RECALL 26V586 / 2026-435 REMEDY INSTRUCTIONS

FOREST RIVER	Make(s): Salem & Wildwood Model(s): SMT263BHXL & WDT263BHXL Model Year(s): 2027 Concern: The exterior griddle may be stowed while still connected to LP Gas.	Repair Code: RC-096-03-00-004857 Allotted Time:.0.30 HR Inspection Code: RC-096-05-00-004856 Allotted Time:.0.20 HR Photo(s) Required: YES Prior Authorization Required: YES Part(s) Kit Number: Part(s) Return: N/A

Figure 1 - BACK OF GRIDDLE

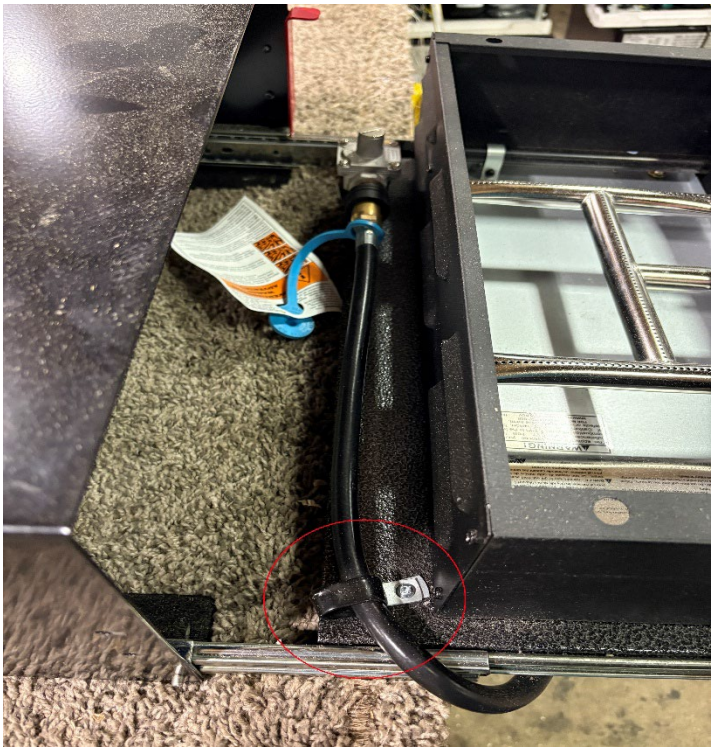
1. LOCATE THE OUTSIDE KITCHEN DOOR AND OPEN IT TO EXPOSE THE EXTERIOR GRIDDLE
2. FULLY EXTEND THE EXTERIOR GRIDDLE
   a. REFER TO FIGURES 1 & 2 FOR WHERE THE P CLAMPS SHOULD BE LOCATED
   b. IF BOTH CLAMPS ARE PRESENT THEN CLAIM INSPECTION CODE
3. IF ONLY ONE CLAMP IS PRESENT ON THE BACK SIDE, THEN ADD THE EXTRA 5/8" COATED CLAMP
   a. THE SECOND CLAMP IS TO BE ADDED ON THE UNDERSIDE OF THE GRIDDLE ON THE BACK RIGHT CORNER (REFER TO FIGURE 2)
4. ENSURE THAT THE EXTERIOR GRIDDLE CAN NOT BE STOWED WITH THE LP SUPPLY LINE CONNECTED
5. CLAIM REPAIR CODE
